OAKDALE WEST ESTATE – MOD 4 (SSD 7348) MODIFICATION REPORT

This letter responds to DPIE's query in the letter of 24.02.20 seeking clear description of any changes to the works approved under SSD-7348. This letter is therefore to be read in conjunction with MOD 4 Modification Report, dated 17 February 2020.

Figure 1 - Approved Civil plans for WNSLR in the vicinity of Lot 9 DP1157476

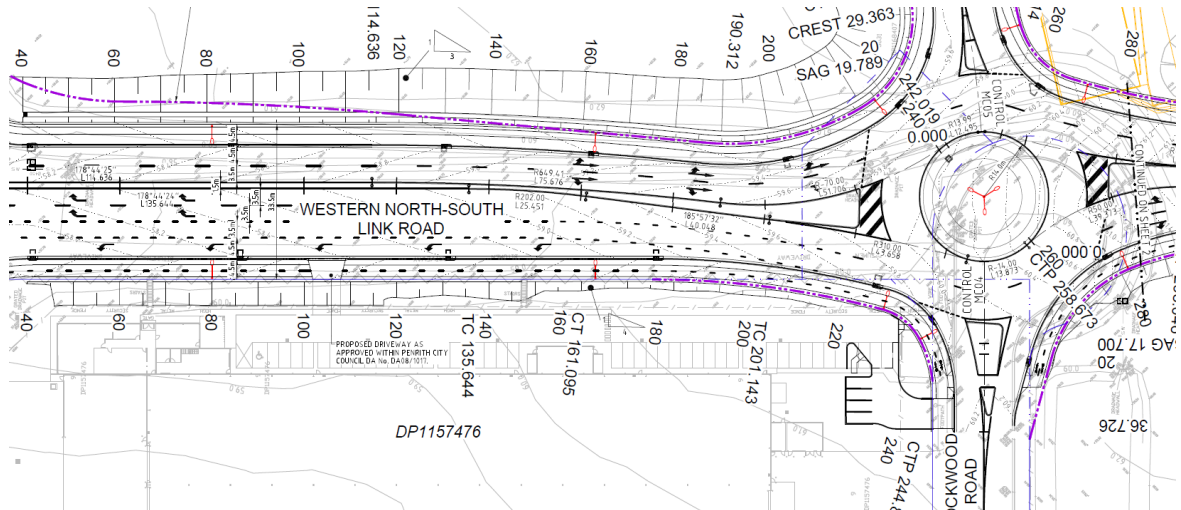
The works approved in SSD 7348 for the WNSLR is included in the civil plans and civil report prepared by AT&L, and included at **Appendix A & B**, which included the section below between Lenore Drive and Lockwood Drive as follows:

Figure 2 - Area of Lot 9 DP1157476, shown in red.

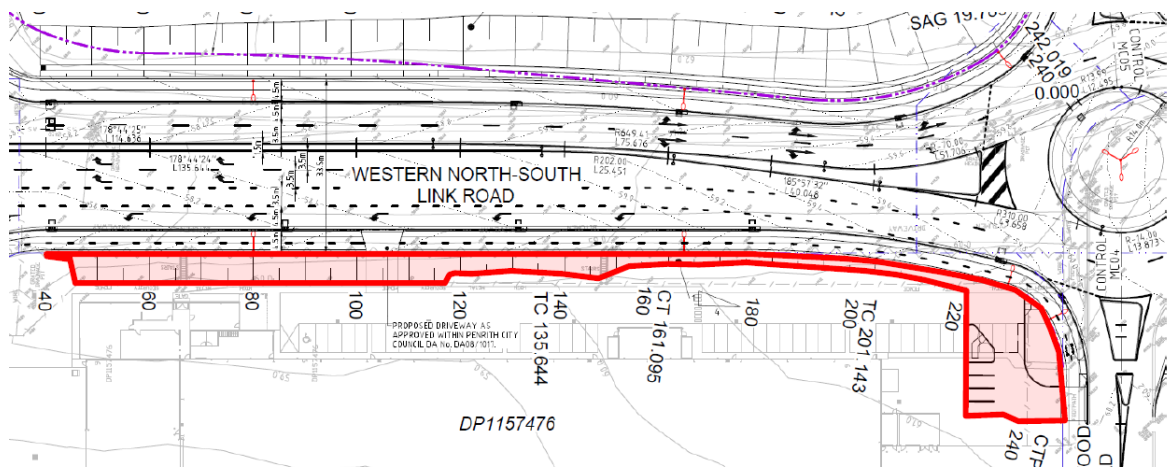
Following approval of SSD 7348 it became evident that Lot 9 DP1157476 (shown in red in Fig.2) was, as an oversight, not referenced in the SSD 7348 approval. This meant that the works within this lot, even though included in the civil plans which were assessed and approved by DPIE, were not legally approved by SSD 7348 as Landowners consent was not provided for Lot 9 DP1157476 (due to a change in ownership of the asset and design changes requested by RMS).

MOD 4 is therefore required to update SSD 7348 to include Lot 9 DP1157476 in the approval reference and ensure that all works within this lot are legally approved as originally envisioned by the SSD 7348 consent.

Figure 3 - Lot 9 DP1157476 works area

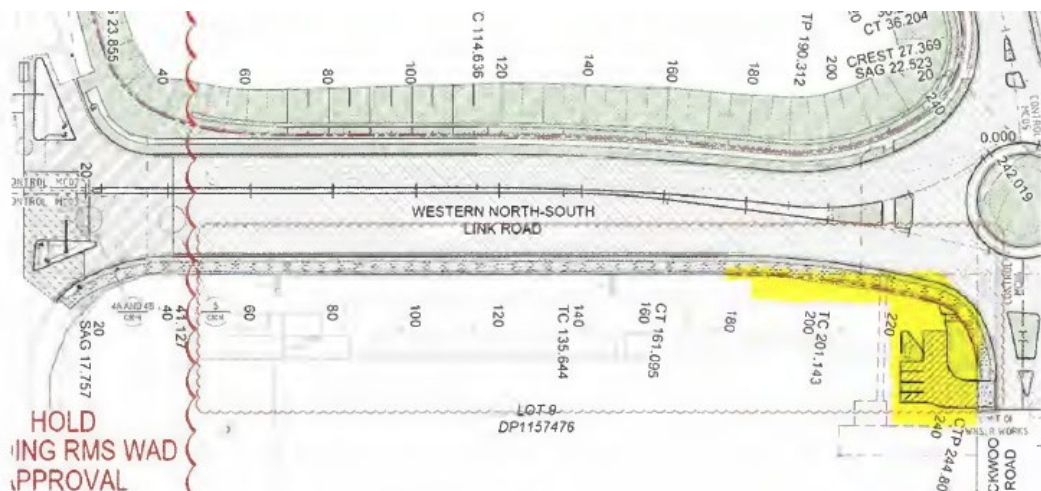
These works are substantially the same to that of what was initially approved under SSD 7348. The changes between initial SSD 7348 and the proposed Mod 4 relate to the following;

- a reduction in landscaping removal and battering into Lot 9 DP1157476 as to reduce the impact to Lot 9 DP1157476 (refer to yellow highlight in extract below);
- minor notation changes to the approved plans;
- minor changes to the footpath and gate entry to the car park.
